Product Change Notification

Product Name: AFL3-12A-BT series

Product Change Notification

AFL3-12A-BT-J1/PC/2G-R11

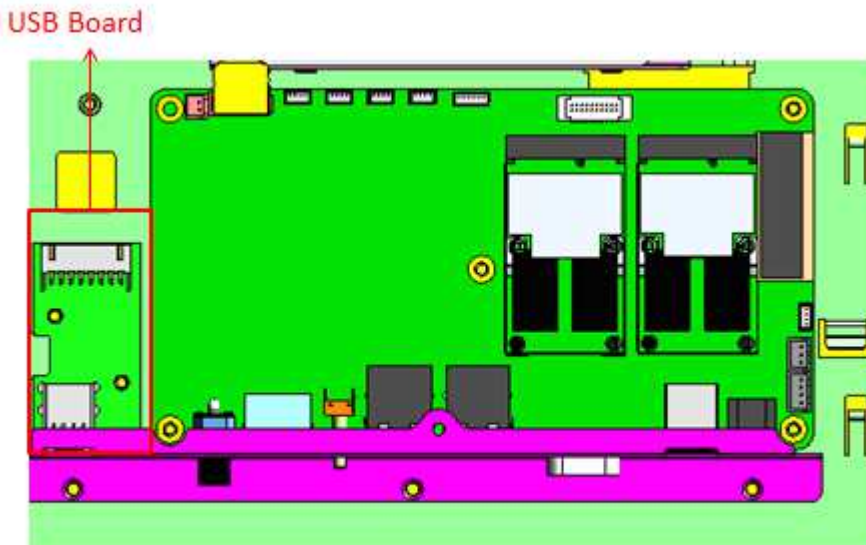
- **USB board upgrade to USB hub board**

Affected P/N	Replacement P/N
134A048-00-102-RS (Bypass two USB 2.0 to two USB2.0)	134F346-00-100-RS (One USB 2.0 convert to two USB 2.0)

- **RFID reader and antenna, AFL3-MF-RFID-KIT02-R10, could be assembly by ATO**
